**METROPOLITAN GOVERNMENT OF NASHVILLE AND DAVIDSON COUNTY**

**STAFF RECOMMENDATION**  
**1010 Forrest Avenue**  
**January 20, 2016**

**Application:** New construction - addition  
**District:** Lockeland Springs-East End Neighborhood Conservation Zoning Overlay  
**Council District:** 06  
**Map and Parcel Number:** 08309012700  
**Applicant:** Josh Summerville  
**Project Lead:** Sean Alexander, sean.alexander@nashville.gov

**Description of Project:** The applicant is requesting approval after-the-fact to retain and complete construction of a covered, enclosed rear addition that enlarged the building by six hundred, seventy square feet (670 sf).

Figure 1: Image showing new and existing roof forms.

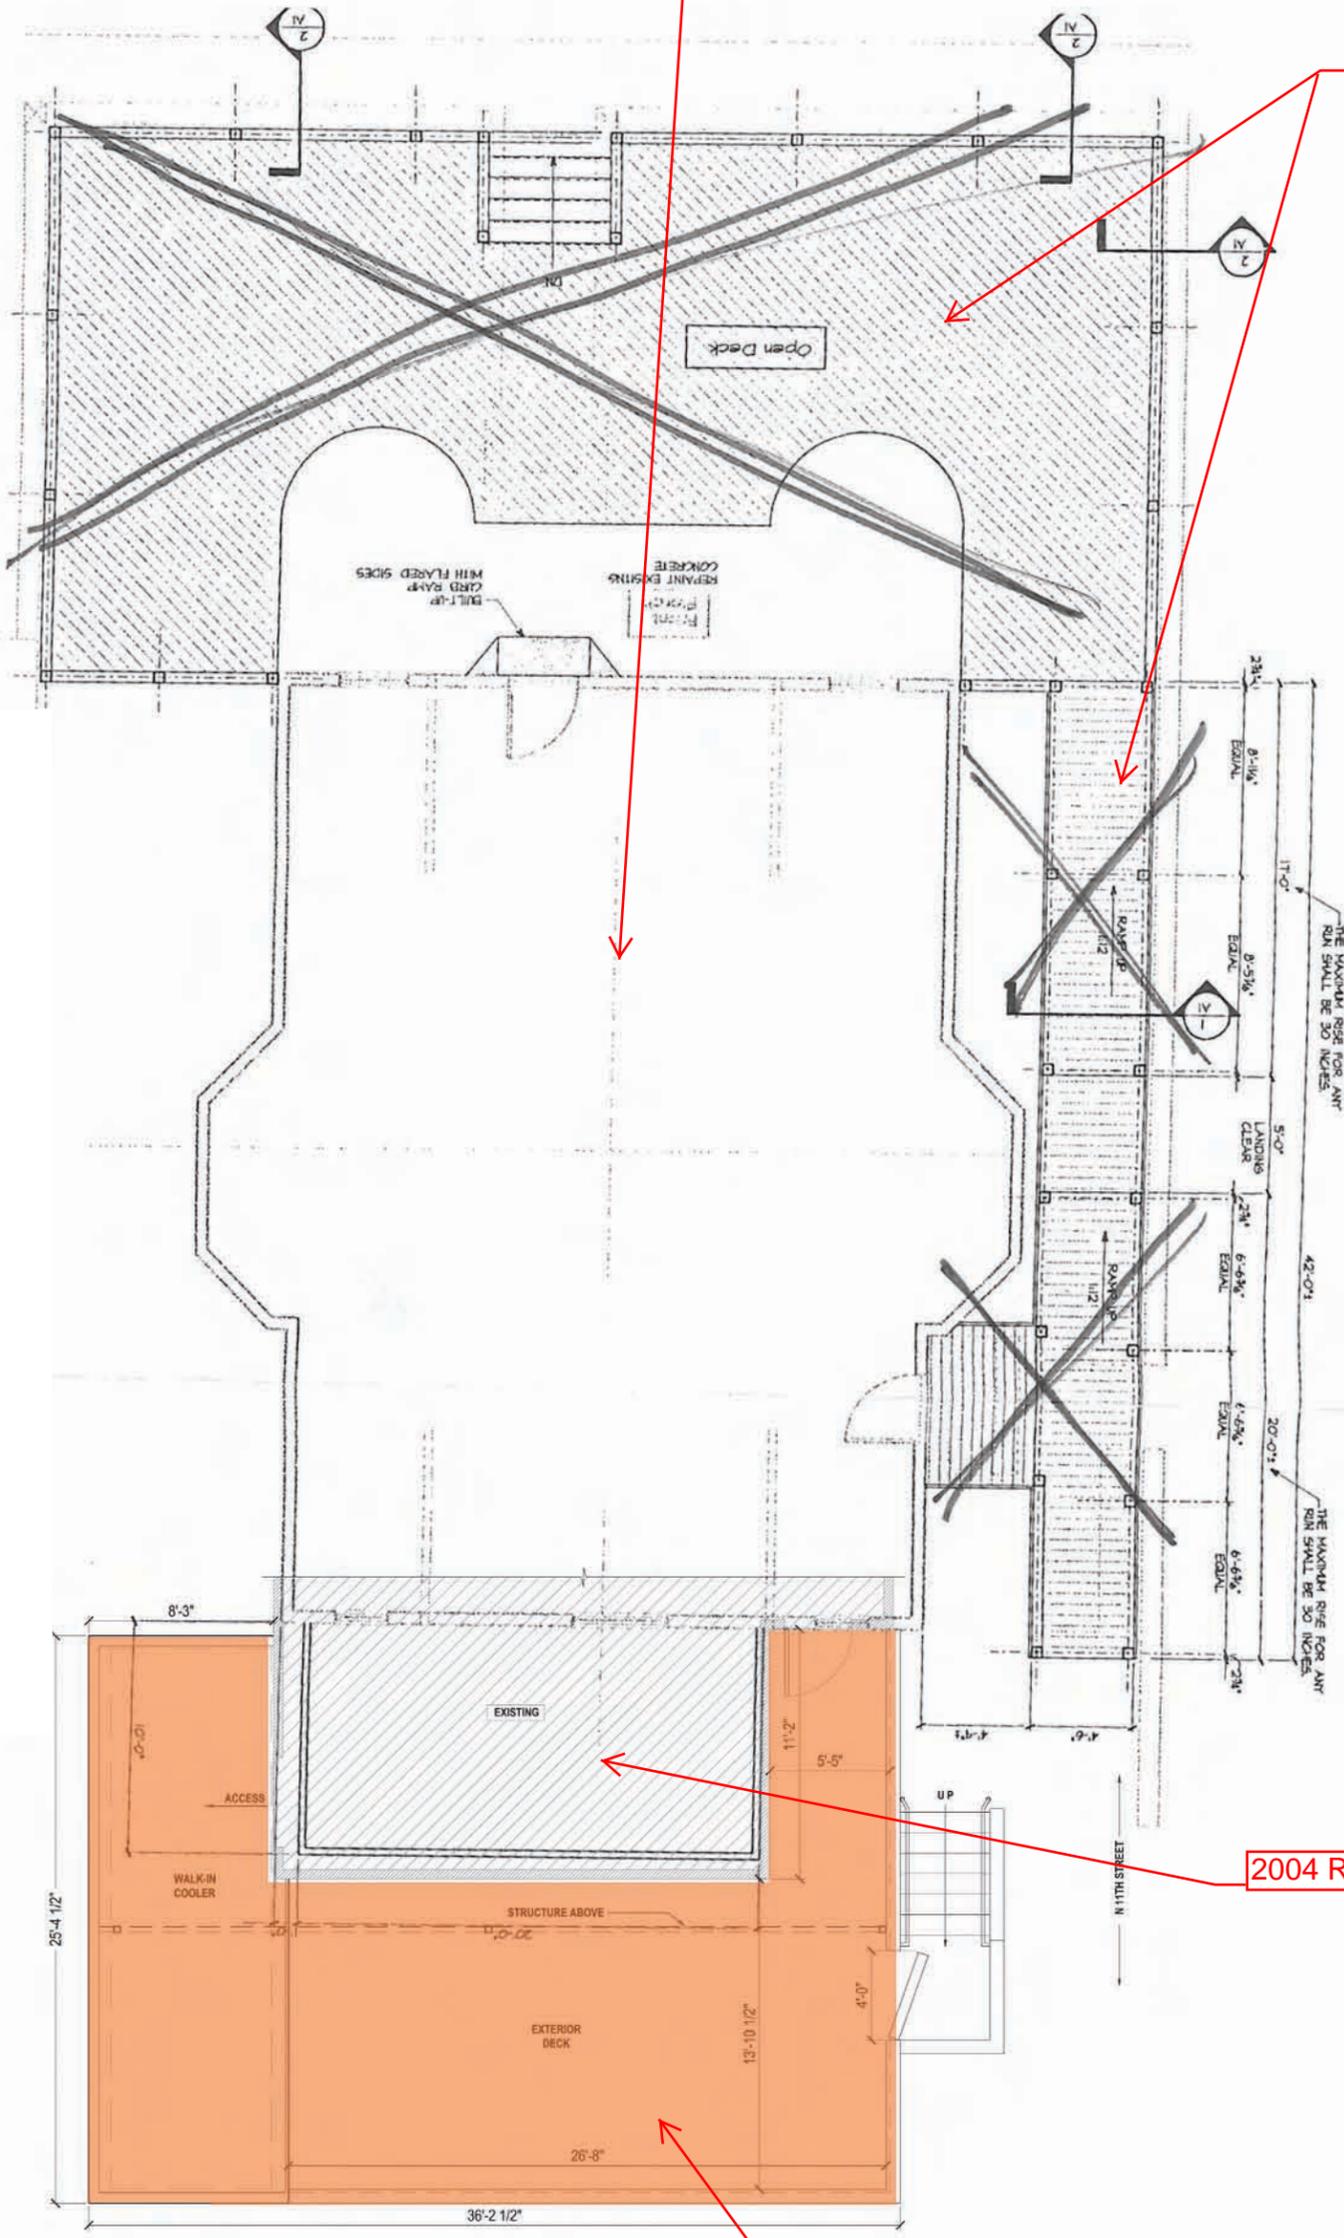
**Location & Removability:** The now covered deck is located at the rear of the building, sitting out two inches (2”) beyond the primary wall of the original building on the left side, and sitting out eight feet, three inches (8’-3”) from the original primary wall on the right. The additional width on the left side is minimal, attributable to a difference in material thickness, but it is highly visible because the left (East) elevation faces South 11<sup>th</sup> Street. The width to the right, while not facing the street, is also highly visible because it is so much greater. Both sides of the addition are also taller than the rear of the house where they connect to it, making the width much more noticeable. Staff finds the addition wider than the existing building on both sides is inappropriate, and does not meet sections II.B.2.a and II.B.2.d of the design guidelines.

**Design, Roof Form:** The roof of the addition is a shed with the lower end at the rear, rising up toward the historic building. Because the shed roof intersects with a rear-facing gable, both sides of the addition have sections of front-facing wall rising over the existing roof. This unusual appearance is particularly inappropriate because the addition is wider than the historic house. Staff finds that the roof of the addition contrasts with the roof form of the historic building, and that it does not meet sections, II.B.1.e, II.B.2.a, and II.B.2.e of the design guidelines.

The applicant do not submit a site plan, therefore Staff cannot determine what the existing setbacks are or what the proposed setbacks would be. From the floorplan, Staff can only determine that the addition is wider than the existing building by several inches on the left side and by more than eight feet (8’) on the right. Despite the mixed context, staff finds the rhythm of spacing of an addition wider on both sides is not compatible with the historically residential building and therefore does not meet section II.B.1.c of the design guidelines.

Staff finds that the vertical wood siding on the lower walls and over the crawlspace and the roof material to be incompatible with those of the historic building, and that the project therefore does not meet section II.B.1.d of the design guidelines.

Staff recommends disapproval of the covered, enclosed rear addition, finding the width, roof form, and materials to be incompatible with the historic building; and that the addition therefore does not meet the design guidelines for the Lockeland Springs-East End Neighborhood Conservation Zoning Overlay.
